MIL-M-52182E
AMENDMENT 1
6 July 1988

MILITARY SPECIFICATION

MELTER, ASPHALT

This amendment forms a part of MIL-M-52182E, dated 24 January 1984, and is approved for use by all Departments and Agencies of the Department of Defense.

FIGURE 2. Gabarit International De Charqment (GIC) clearance diagram.

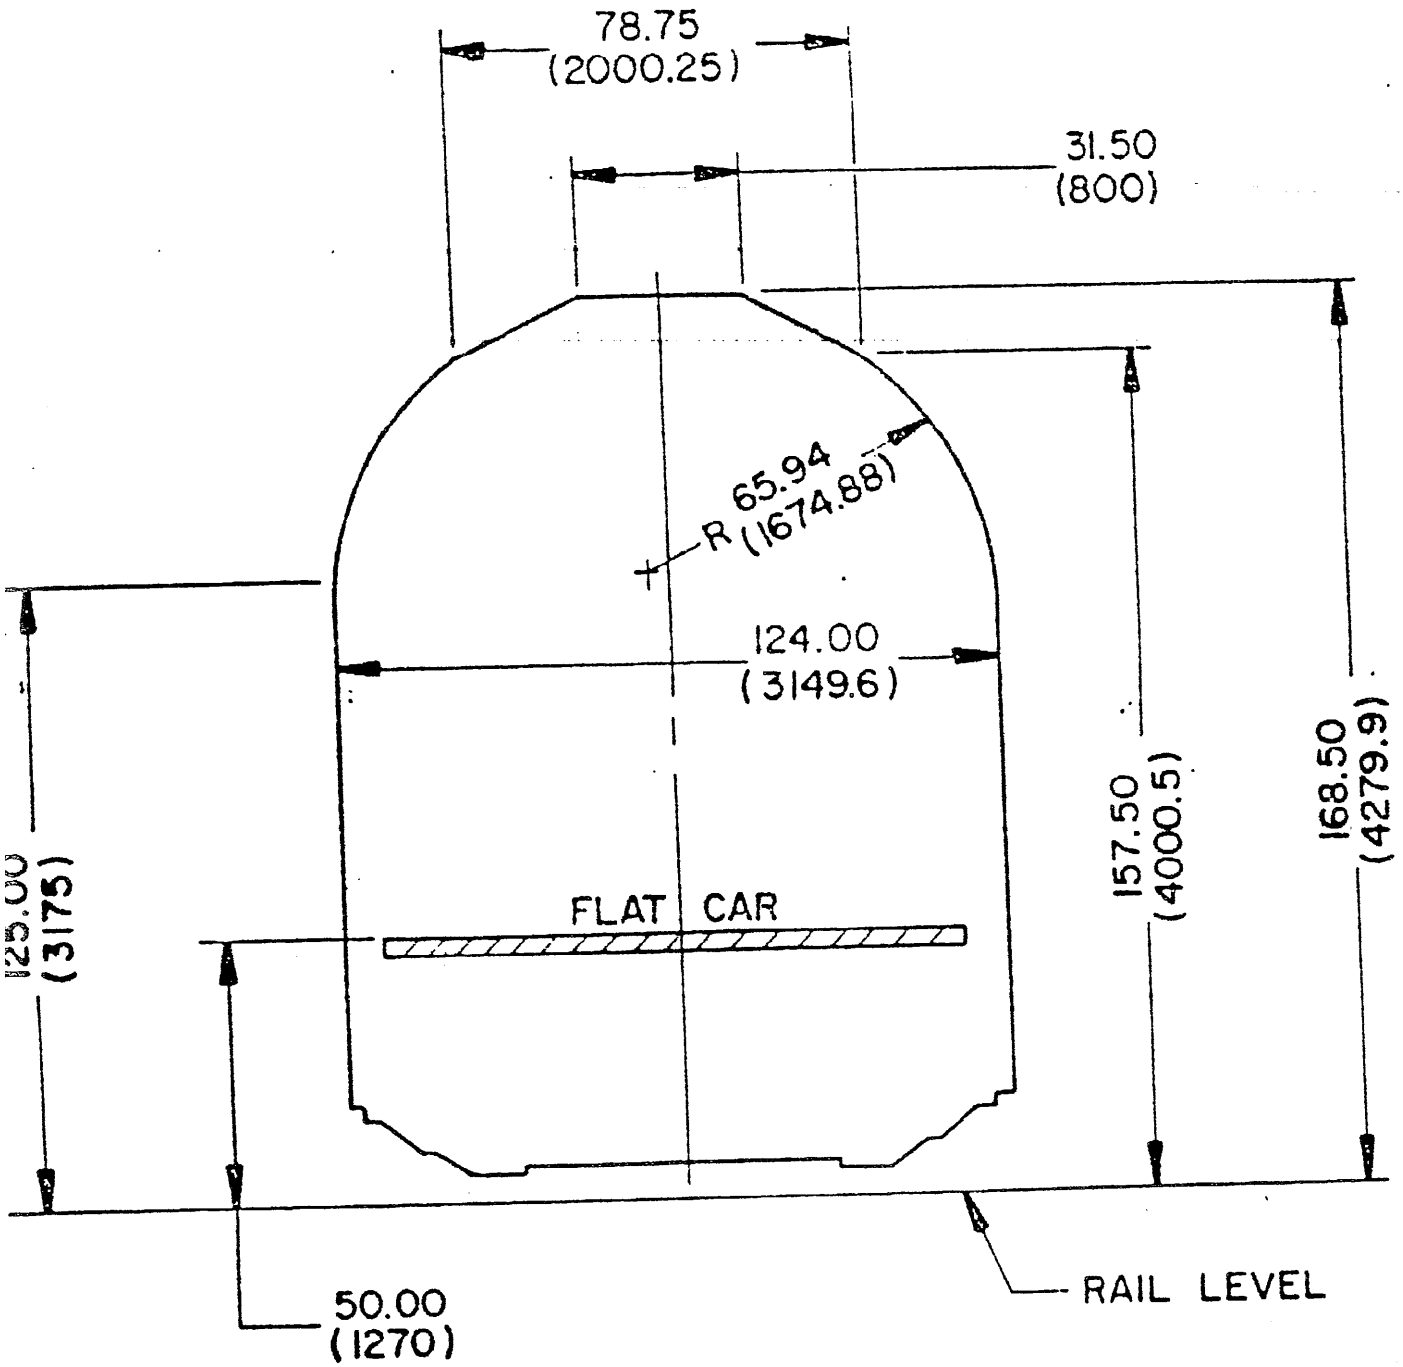
'*3 .13.4 Rail transportability. The asphalt melter shall be rail transportable in CONUS and NATO countries without restrictions. The asphalt melter, shall have a dimensional profile within the Gabarit International de Chargement (GIC) outline diagram (see figure 2) when loaded on a 50-inch high rail car. The asphalt melter shall be capable of with shock loads resulting from rail impact testing in accordance with 4.5.2.8 without failure, damage, or permanent deformation.

Add new figure 2 after page 18.
